# **68-80 Beauchamp Road, Hillsdale, Affordable Housing**

Integrated Water Management Plan

| Revision | Date     | Originator   | Checker    | Approver   | Description               |
|----------|----------|--------------|------------|------------|---------------------------|
| C        | 06.03.26 | M. Beardsell | A. Tarshan | D. Fettell | Response to SSDA comments |

| <b>9</b>  | <b>Responses to Bayside Council Comments</b>                              | <b>23</b> |

Figure 5-1: Water Quantity Catchment Plan

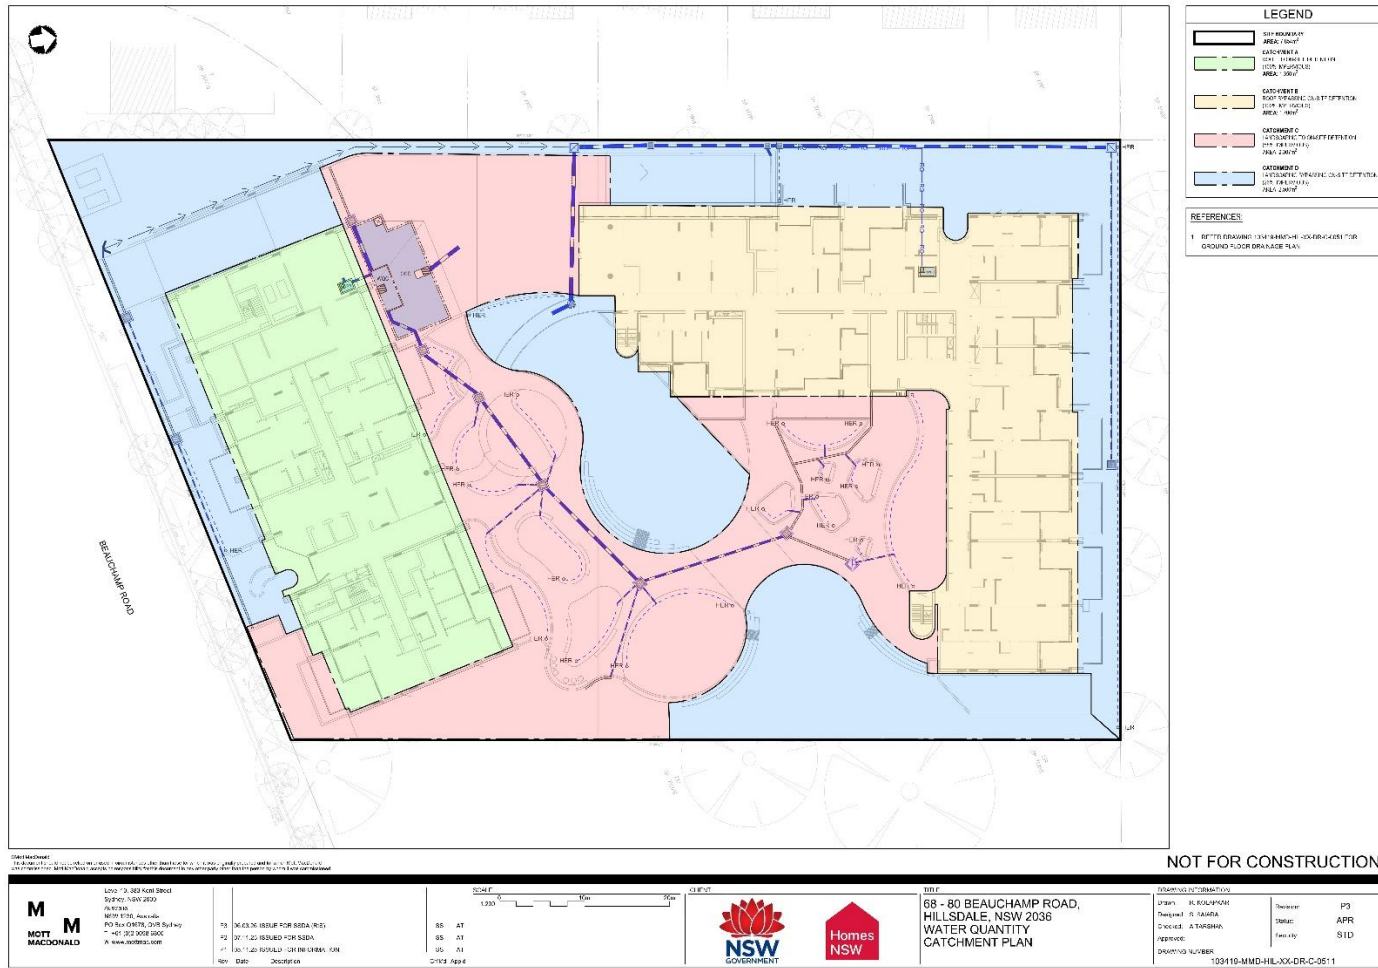
| Bayside Council Comments and Mott MacDonald Response |   |   |
|--|---|---|
|  | b. The water quantity catchment plan does not accurately reflect the stormwater design and is to be updated.  | Noted, Mott MacDonald (MM) has updated the quantity catchment plan in the latest issue of the Integrated Water Management Plan (Rev C)  |

Figure 6-2: MUSIC Model

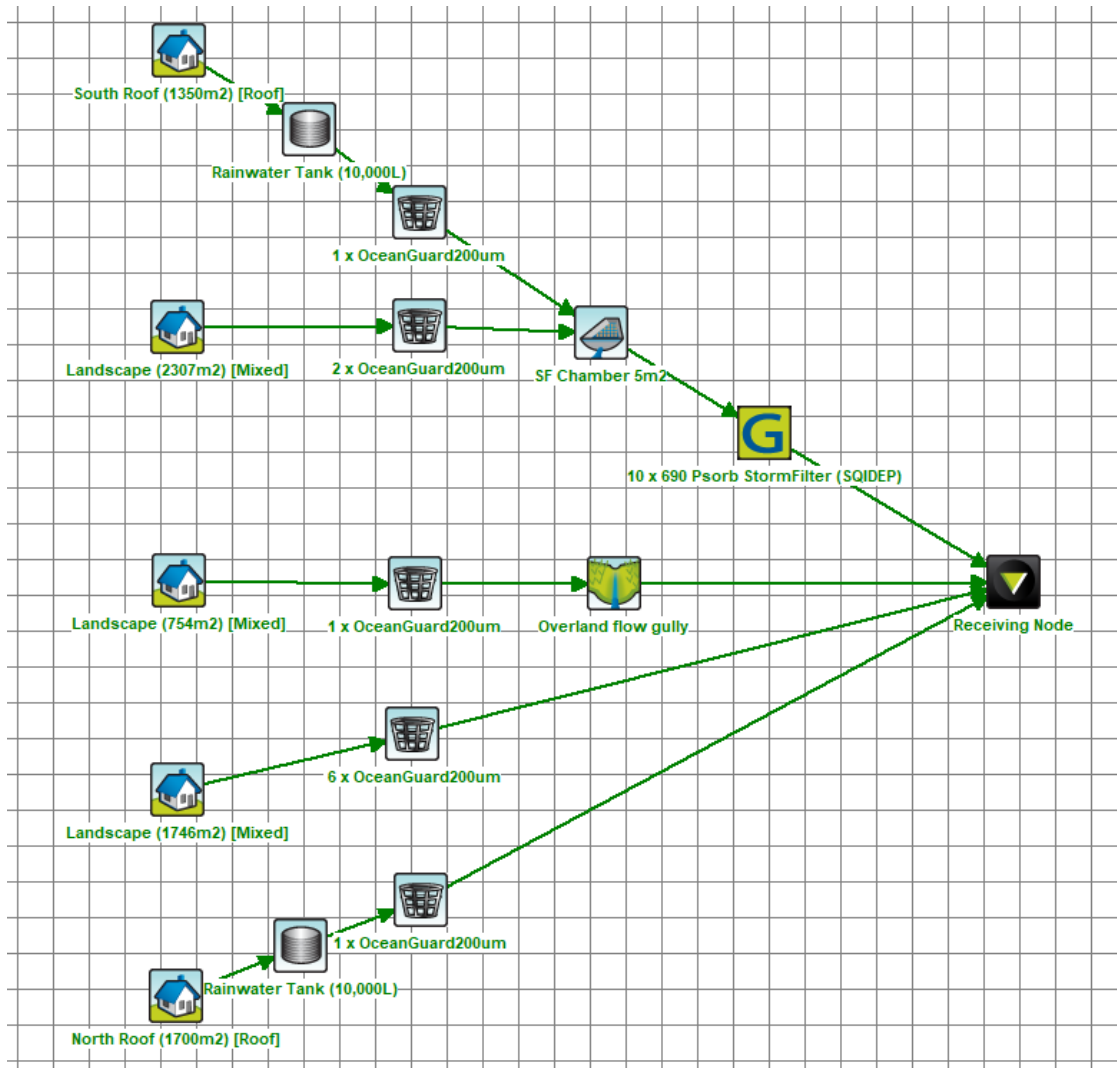
| Bayside Council Comments and Mott MacDonald Response |   |   |
|--|---|---|
|  | b. Enlarge MUSIC model snapshots to clearly show all nodes and areas (m <sup>2</sup> ), consistent with the catchment plan.   | Noted, Mott MacDonald (MM) has rectified this in the latest issue of the Integrated Water Management Plan (Rev C)   |

| d. Resolve inconsistencies between Figures 6-1 and 6-2 and Section 6.1.3 of the Integrated Water Management Plan.   | Noted, Mott MacDonald (MM) has rectified this in the latest issue of the Integrated Water Management Plan (Rev C)  |
